FOREST GROVE PLANNING COMMISSION MEETING

Site Plan and Design Review
Staff Report and Recommendation

REPORT DATE:	March 17, 2017
HEARING DATE:	March 27, 2017
LAND USE REQUEST:	Site Plan and Design Review of a proposed 20,220-square-foot three-story commercial building; a 3,149 square-foot day care facility; a coffee kiosk drive-through; and parking
FILE NUMBER:	311-16-000200-PLNG
PROPERTY LOCATION:	3424 Pacific Avenue; 1943 Oak Street; and 1954 Poplar Street
LEGAL DESCRIPTION:	Washington County Tax Lots 1S3 5BA-300, 500, 501 and 1700
OWNER/APPLICANT(S):	Applicant/Property Owner: PacOak Development LLC (Jared Thompson), 1951 Oak Street - Suite A, Forest Grove, Oregon 97116 Applicant's Representative: DOWL (Serah Breakstone). 720 SW Washington Street - Suite 750, Portland, Oregon 97205
COMPREHENSIVE PLAN MAP AND ZONING MAP DESIGNATIONS:	Community Commercial (CC) Community Commercial (CC)
APPLICABLE STANDARDS AND CRITERIA:	City of Forest Grove Development Code ▫ §10.3.300 - .340 *Commercial and Mixed Use Zones* ▫ §10.7.200 et. seq. *Solid Waste and Recycling* ▫ §10.8.000 et. seq. *General Development Standards* City of Forest Grove Design Guideline Handbook ▫ Focus Area II *Commerci

SHEET
C2.0

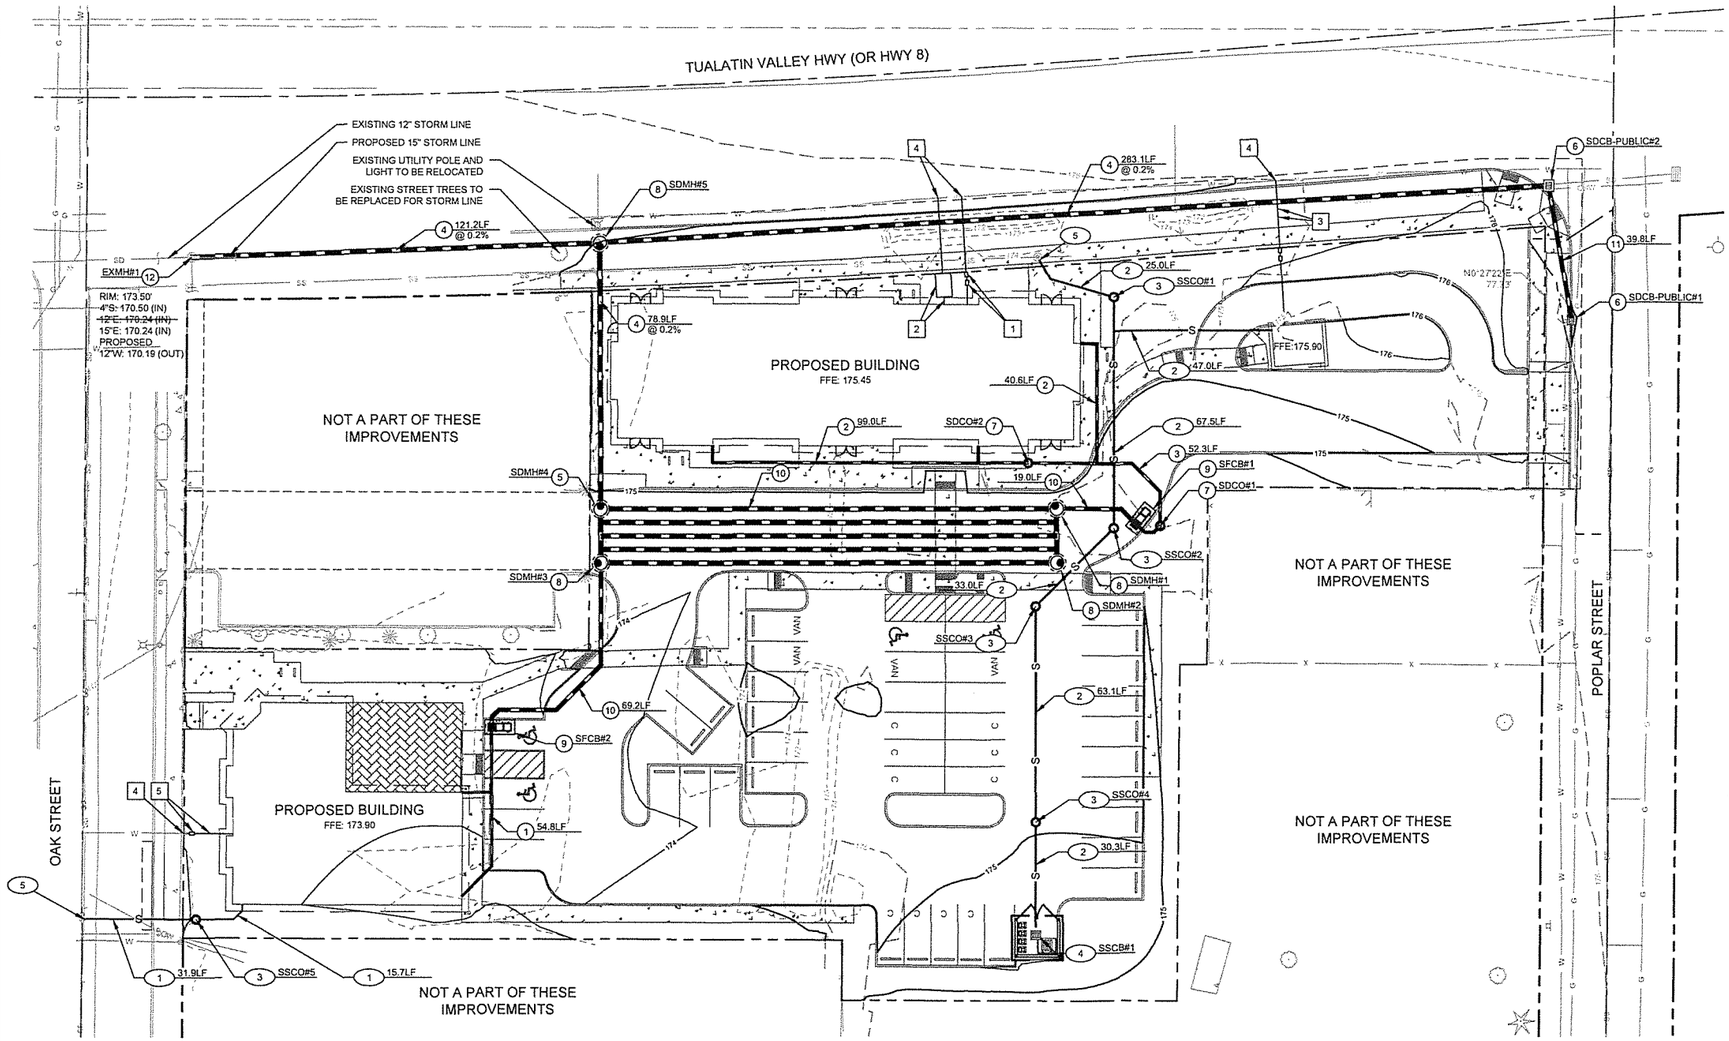
Staff is concerned about the access to and queueing for the coffee kiosk. The kiosk would be located along Pacific Avenue east of Building One. It could be accessed from both Oak and Poplar streets. It appears from the application that there would be only one service window, on the north elevation, which means that vehicles would most likely enter the drive aisle from Poplar Street (i.e., traveling east-to-west). The application indicates that there is queueing space for four vehicles.

Eugene's code is the most directly comparable to this request, as the kiosk in this proposal would have a floor area of approximately 200 square feet. However, while the proposed queueing would comply with Eugene's minimum standard, the proposed design would not provide sufficient queueing for peak hour demand. Any more than four queued vehicles would be backed up into Poplar Street, and possibly into the Pacific Avenue intersection, thus potentially endangering other traffic.

To address the stacking issue, staff is recommending a **condition** to reconfigure the drive-through so that vehicles would travel west-to-east. That would provide on-site stacking space for more than ten vehicles along the central drive aisle, all the way to Oak Street. Vehicles could still access the drive-through via Poplar Street, but they would have to travel about 80 feet into the site before turning into the drive-through lane.

- The walkways do not extend to all spaces. Staff is proposing a **condition** so that the walkway along the east car park would be extended south to abut all of those adjacent spaces and to the spaces next to the trash enclosure.

- While the walkway widths exceed the minimum required, staff has included a **condition** to require a minimum 6 ½-foot-width for walkways adjacent to the parking stalls. The additional width would allow for vehicle overhang, and would eliminate the need for wheel stops, which can be a tripping hazard and a barrier to mechanized parking area cleaning equipment. As the proposed standard parking stalls would be 18 feet long, shortening them by 1-½ feet would not compromise their functionality since the curb/wheel stop would be at the 16-½-foot mark, and still function as a full-sized space.

a. The proposal includes 4 ADA-accessible spaces; only 2 are required for car parks with 26 to 50 spaces. While this would not change the overall supply of parking, 2 of those spaces could remain available for general use versus being specifically designated as ADA-spaces only.

SHEET
C4.0

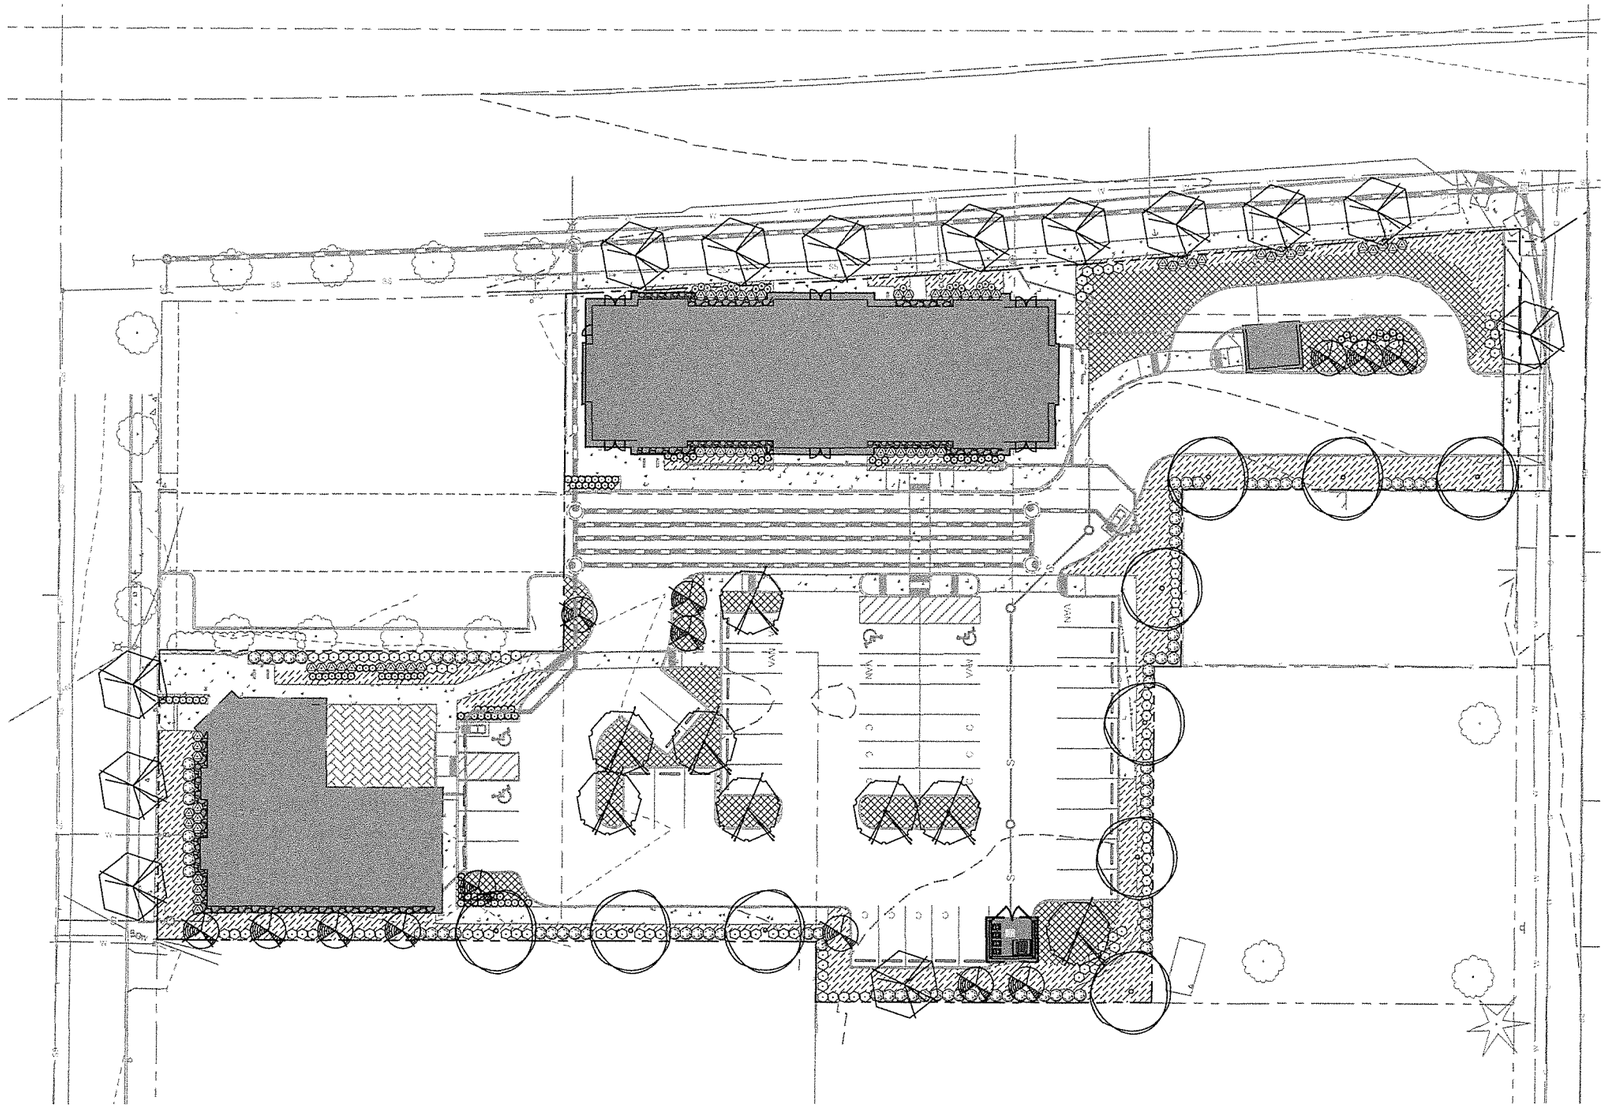
The preliminary Utility Plan (Exhibit A Sheet C4.0) notes that "Existing street trees to be replaced for storm line". If in fact the Pacific Avenue street trees adjacent to 1951 Oak Street need to be removed to allow for the installation of a new storm pipe, and if the new pipe is to be located within the parkway as indicated, staff is recommending two **conditions** of approval:
